**Village of Thiensville
Plan Commission
AGENDA**

**CHRIST ALONE 247 SOUTH MAIN STREET
CHRIST ALONE EVANGELICAL LUTHERAN CHURCH
PLAN COMMISSION REVIEW**

Re: Christ Alone Building Addition
Site Plans and Storm Water Review

BUILDING ADDITION SITE DEVELOPMENT PLANS VILLAGE OF THIENSVILLE, WISCONSIN

DESCRIPTION:
GRADING & DRAINAGE PLAN

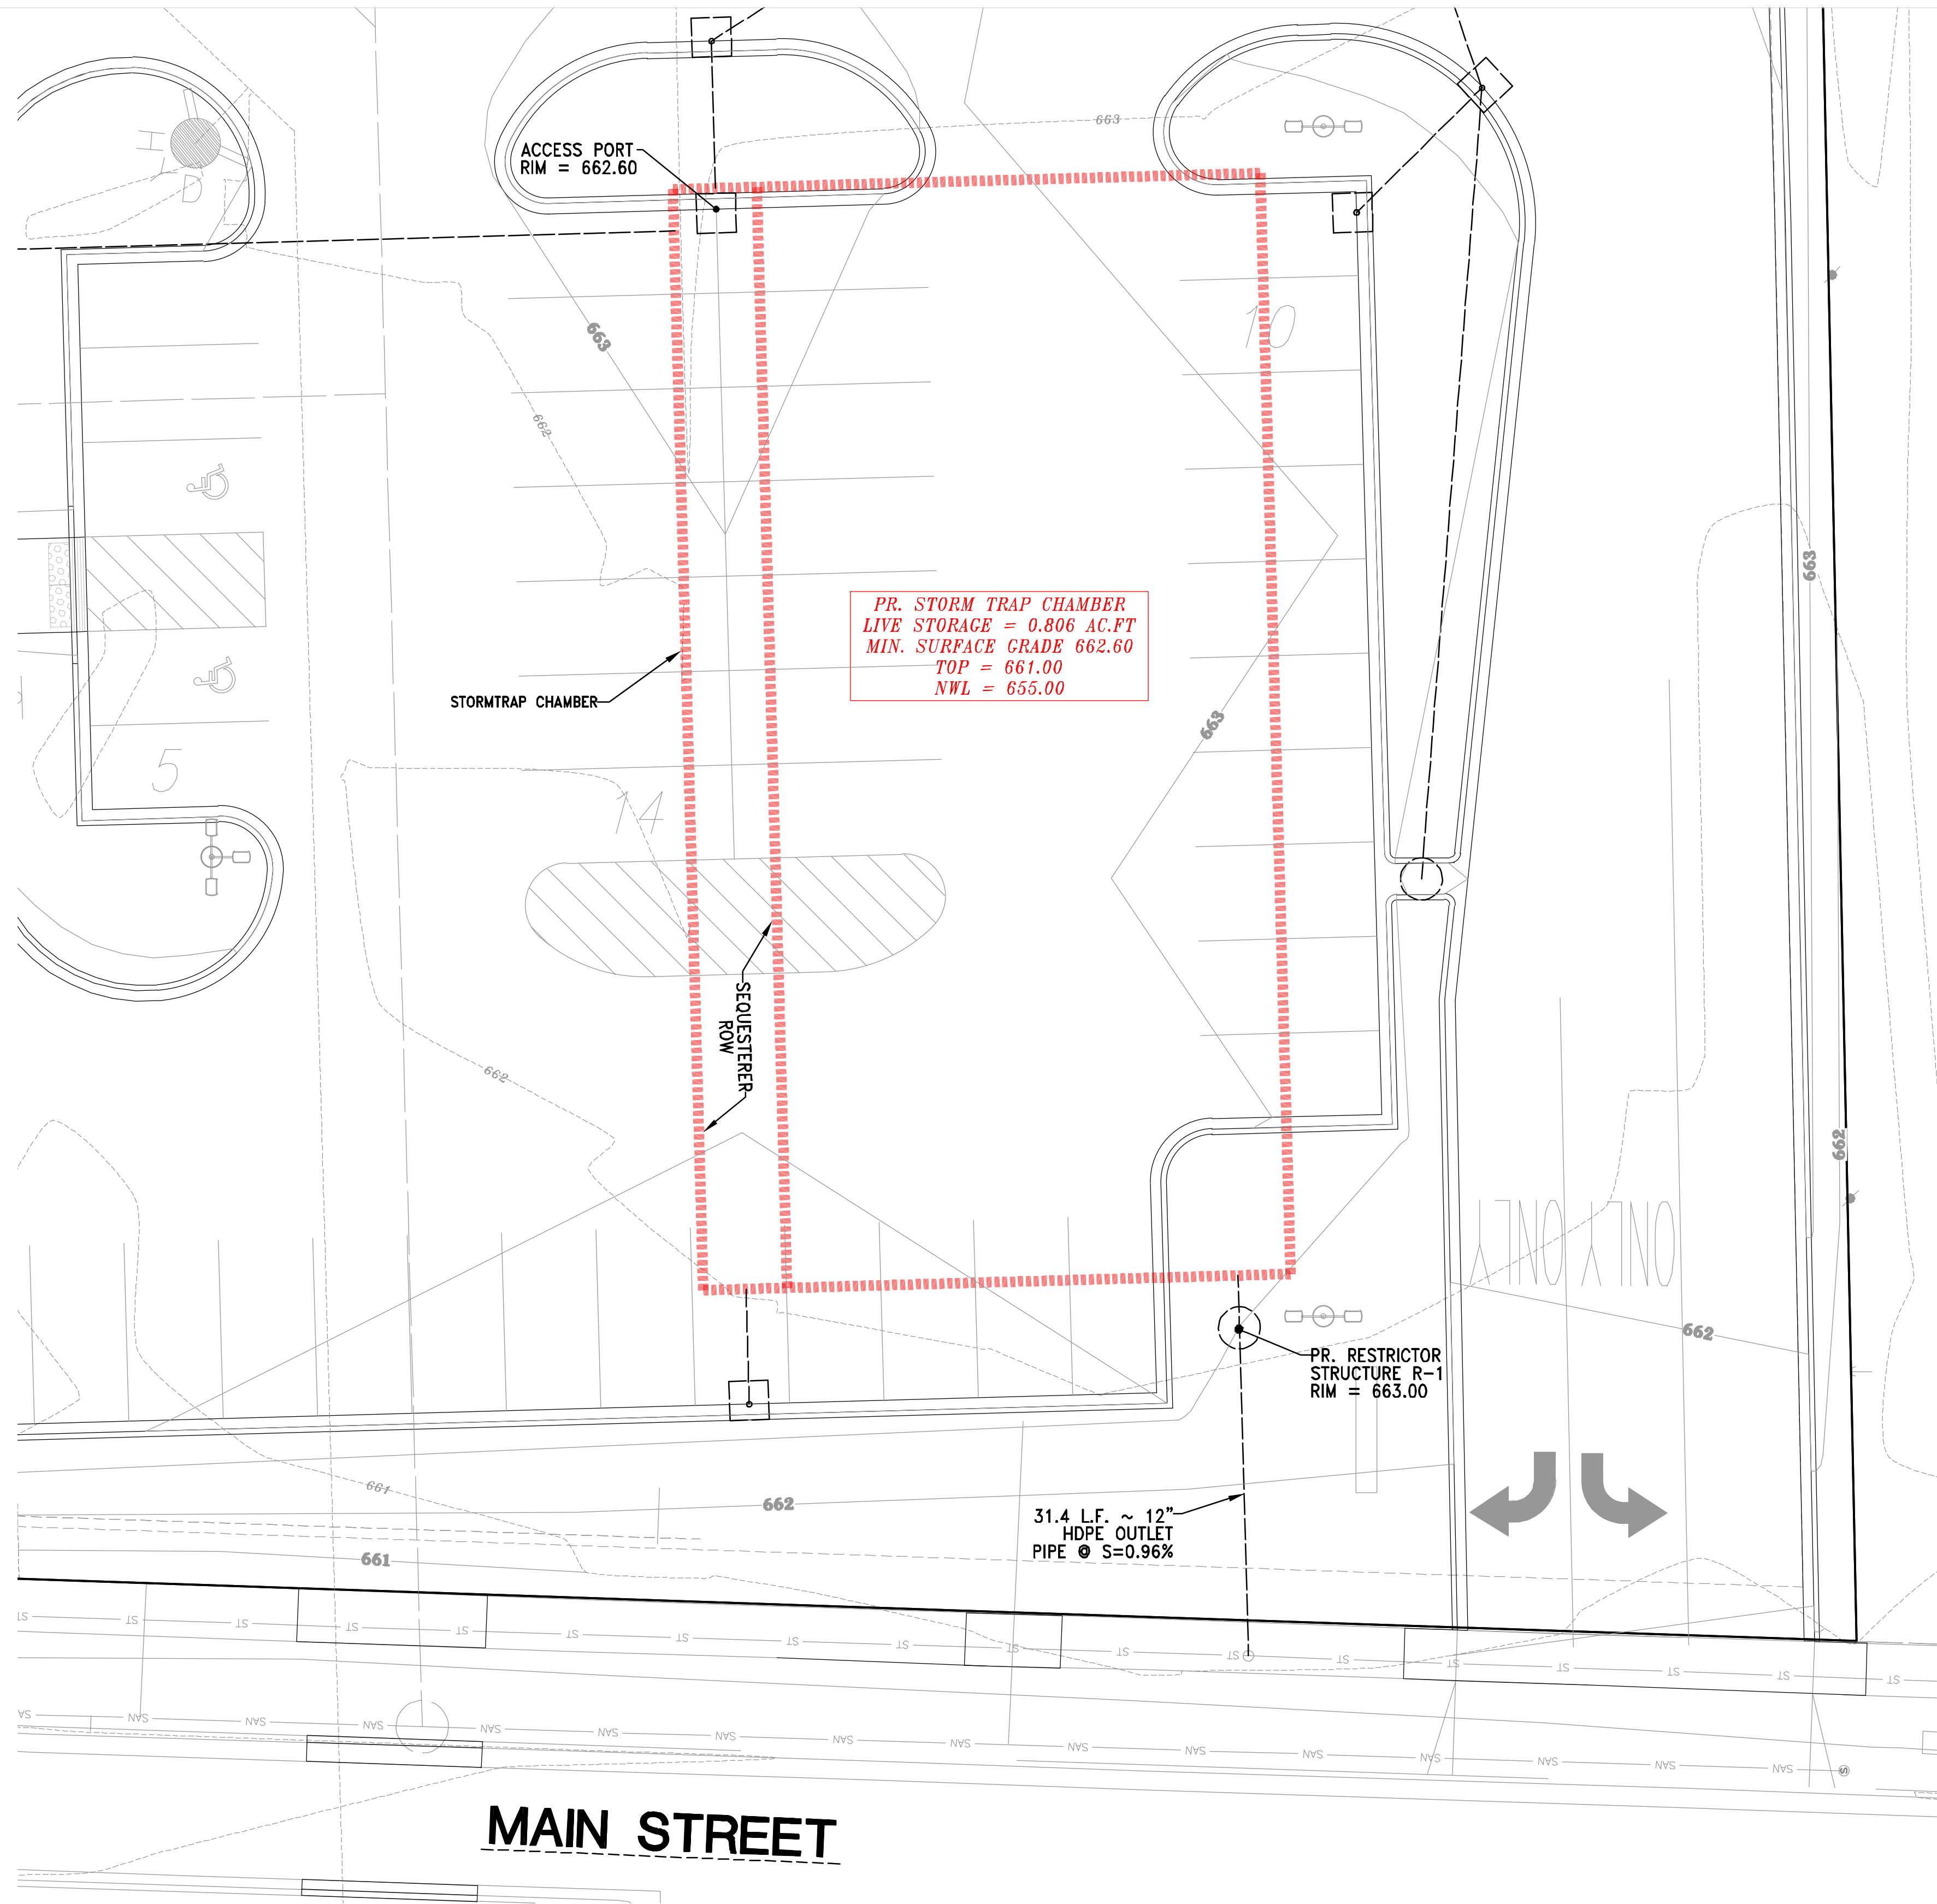
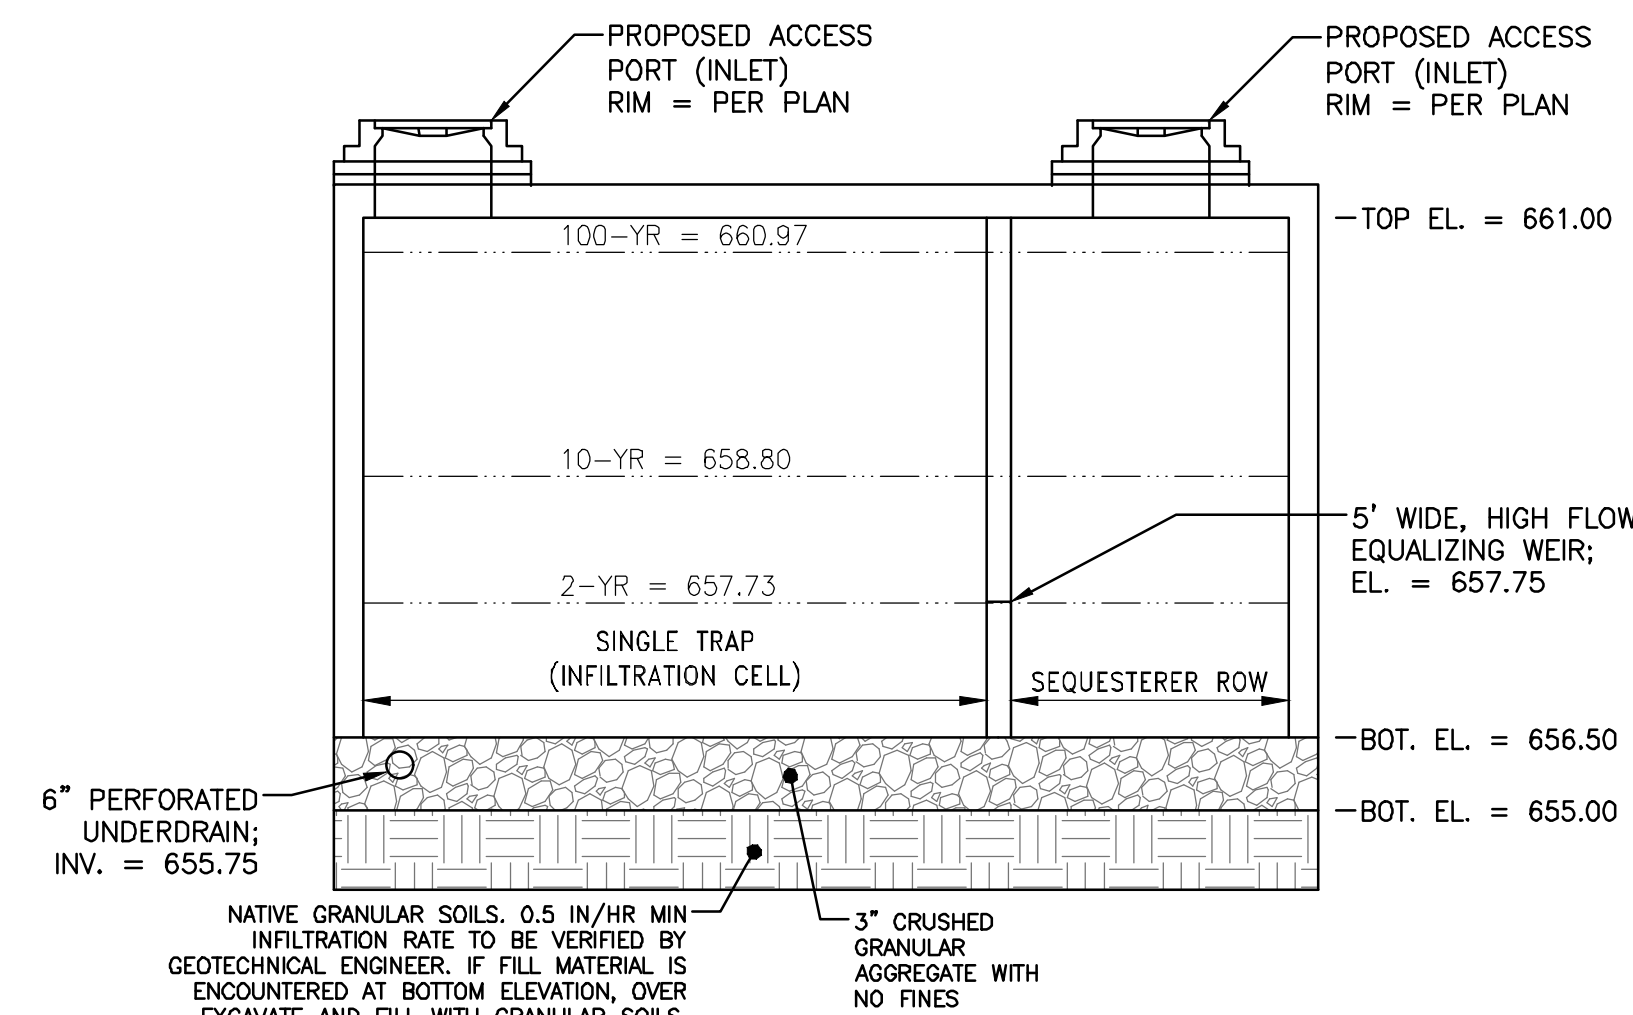
5. Plan Sheet C2.0 Grading & Drainage Plan:
 - a. Show locations of catch versus reject curb and gutter.
 - b. Review and revise spot grades between new building additions, as some of the grades are in the 550's elevations.

DESCRIPTION:
UNDERGROUND
DETENTION
SYSTEM PLAN

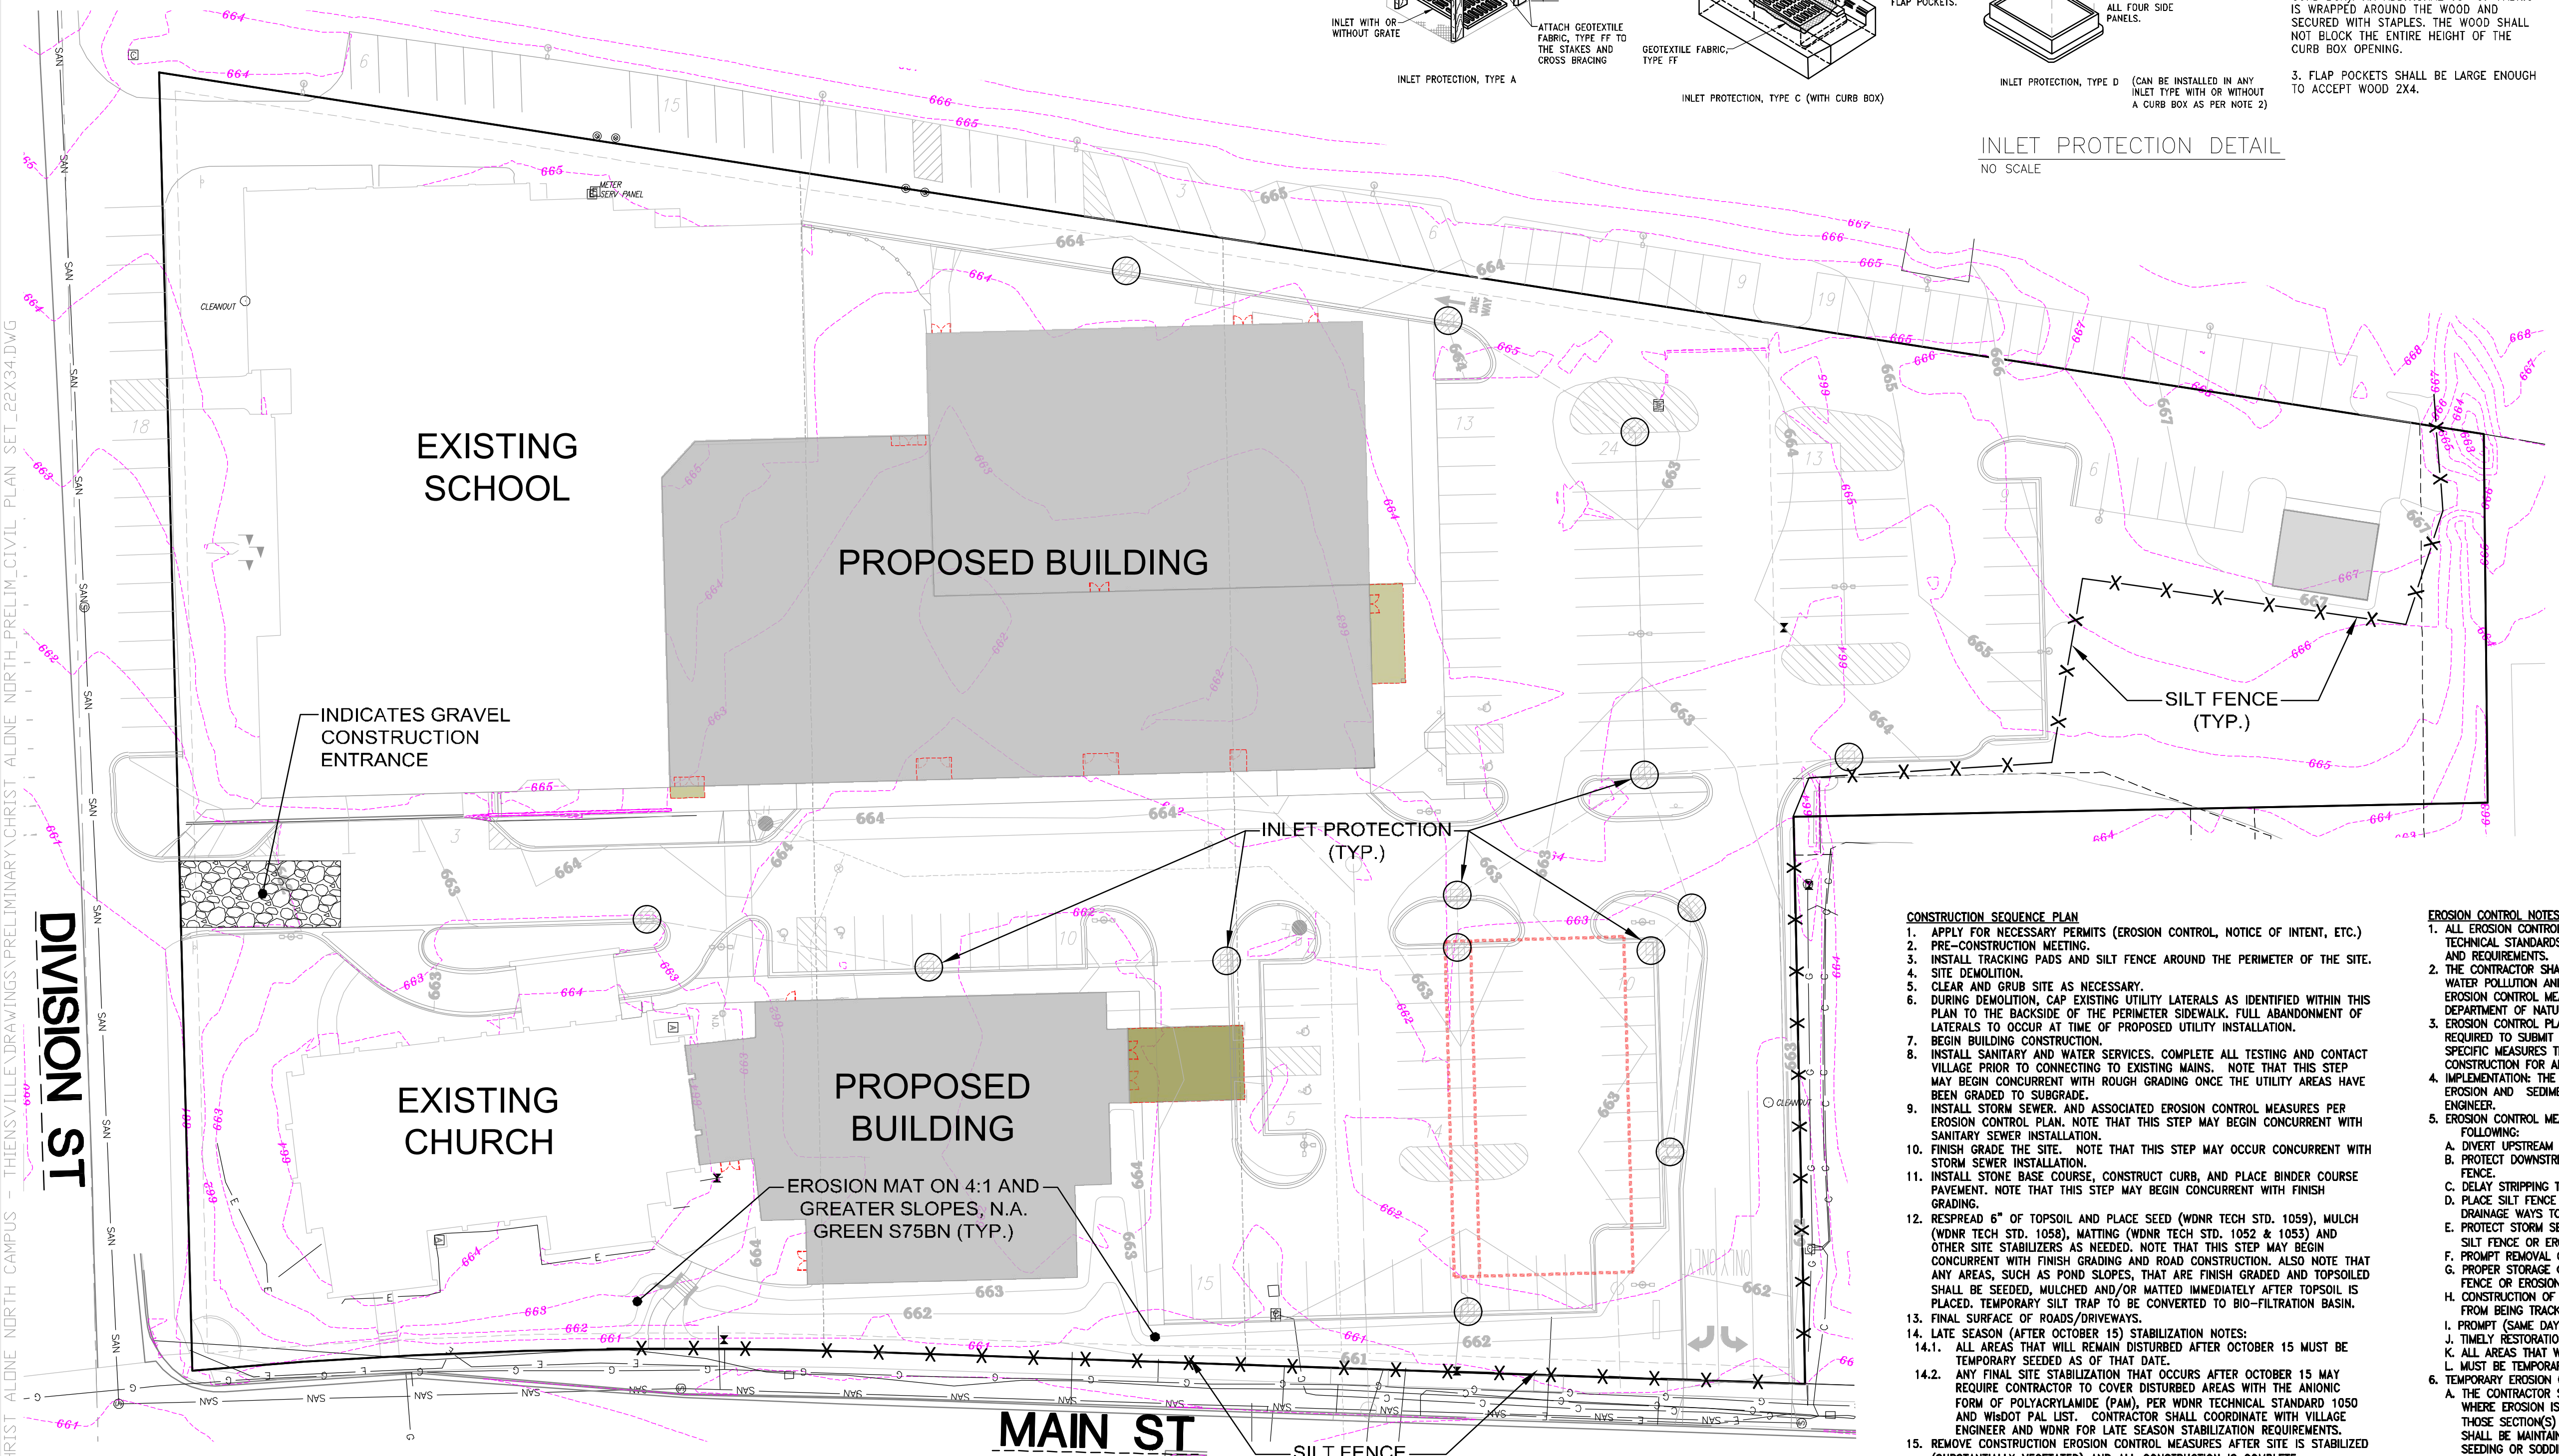
6. Plan Sheet C2.1 Underground Detention System Plan:
 - a. On the Restrictor Structure detail, there's a note for the 3" orifice to be partially plugged to a 4" diameter during construction. Is this the correct size?
